Subject: FRONT / REAR STABILIZER NOISE PREVENTION	Bulletin No: 02-006/13
	Last Issued: 11/25/2013

BULLETIN NOTE

- This bulletin supersedes the previous bulletin 02-006/13, issued on 06/04/13. The APPLICABLE MODEL(S)/VINS has been revised.
- Changes are noted below in Red beside the change bar.

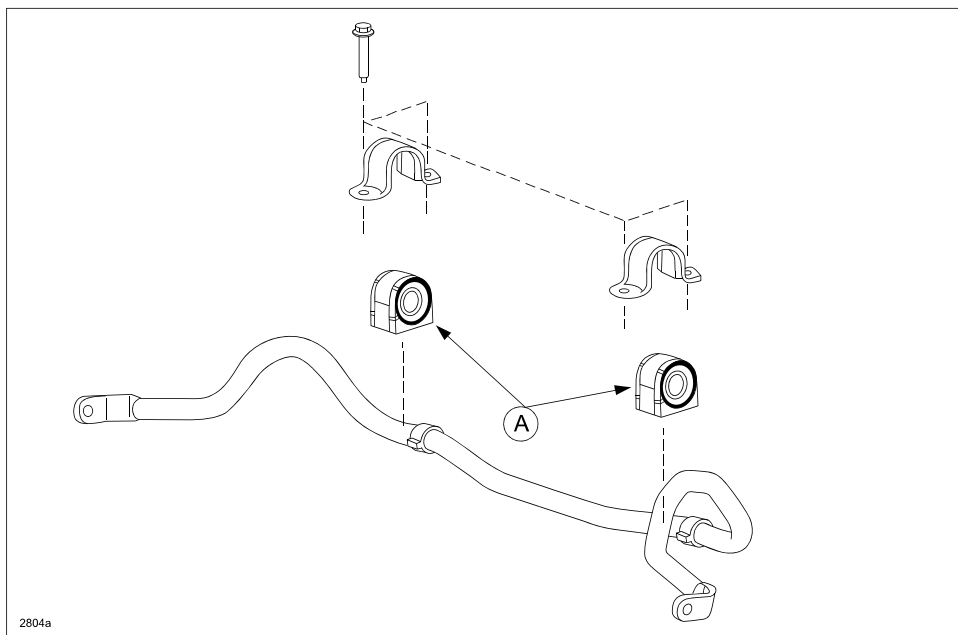
Beginning with the newer models (CX-5 and Mazda6), grip type front and rear stabilizer bushings (A) have been incorporated for noise prevention purposes. If any type of grease or lubrication is applied to the bushings, it may create noise due to bushing slippage (CX-5 front bushings shown below).

NOTE: To prevent noise from occurring, never apply any type of grease or lubrication to the front or rear stabilizer bushings.
